Re: Gasland Cortlandt
AKRF Review Comments
MC Project No. 19003182A

PRELIMINARY CONCEPT PLAN
 FOR
GASLAND CORTLANDT
 (LEFT TURN ALTERNATE)
 U.S. ROUTE 6
 TOWN OF CORTLANDT
 WESTCHESTER COUNTY
 NEW YORK

SHEET TITLE:
CONCEPTUAL IMPROVEMENT PLAN

SHEET NUMBER:
CIP-1R-3 LANE

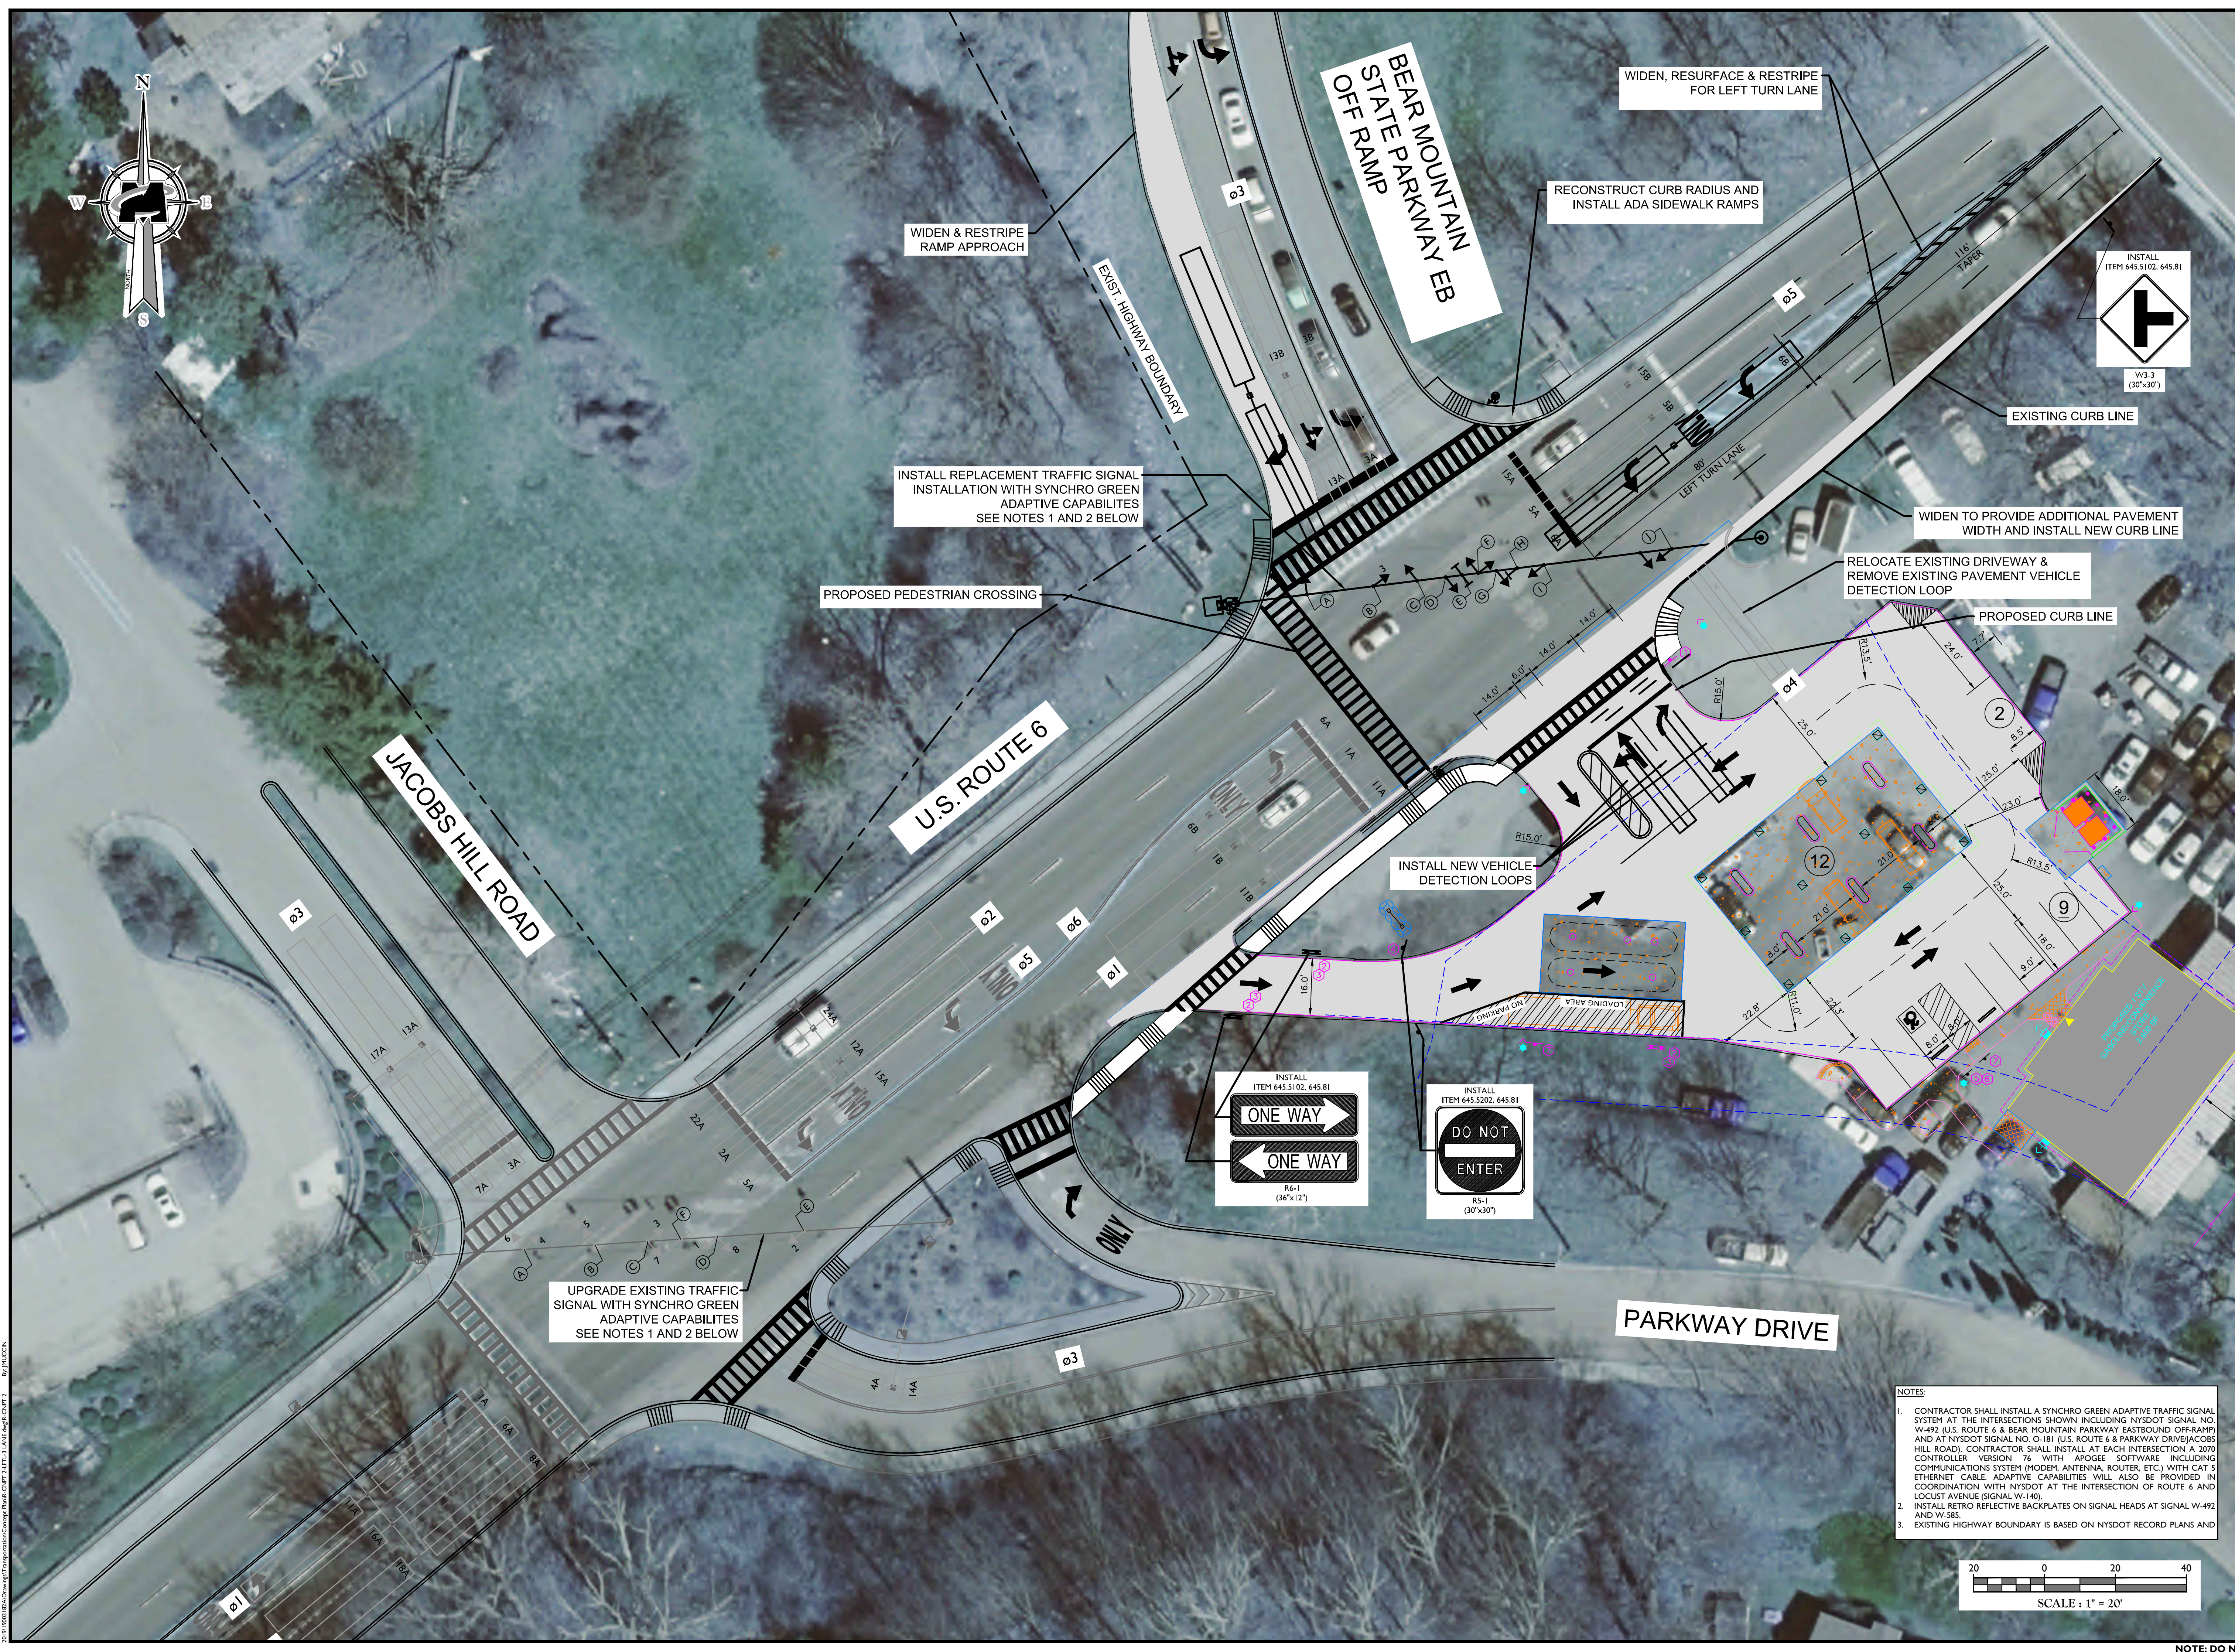
2. There are discrepancies between the proposed striping at the intersection of Route 6 and the Bear Mountain Parkway eastbound ramp/site driveway. The site plan shows three exclusive lanes (left- tum, though, right-tum) exiting the site. However, the capacity analysis analyzes either a left-tum, and shared through/right-tum configuration or a left-tum, shared left-tum/through, and right-tum configuration. In addition, the southbound Bear Mountain Parkway ramp approach is striped as a left-tum only and right-tum only lane, however there are through movements proposed to the gas station.

6. The proposed striping and crosswalks shown on the conceptual improvement plans should be included in the revised site plans. In addition, the sidewalk and crosswalk across the entrance only right-turn driveway should be parallel to Route 6 and located directly adjacent to the roadway to provide better sight distance of crossing pedestrians to motorists. Truck turning diagrams for all feasible movements to/from the site as well as within the site for fueling trucks/refuse should be provided with the revised site plans.

Response: *The Applicant has proposed relocating and reconstructing the existing site drive and will provide a signal controlled two-lane exit from the site. Also, as part of the project improvements, it will include roadway widening and the necessary traffic signal upgrades as per NYSDOT requirements and shown conceptually on Drawing CP-1R. The final details will then be part of the NYSDOT Highway Work Permit plans.*

Response: The striping and repositioning of crosswalks are shown on the revised Conceptual Access Improvement Plan. The truck turning diagrams have been provided as part of the site plan set.
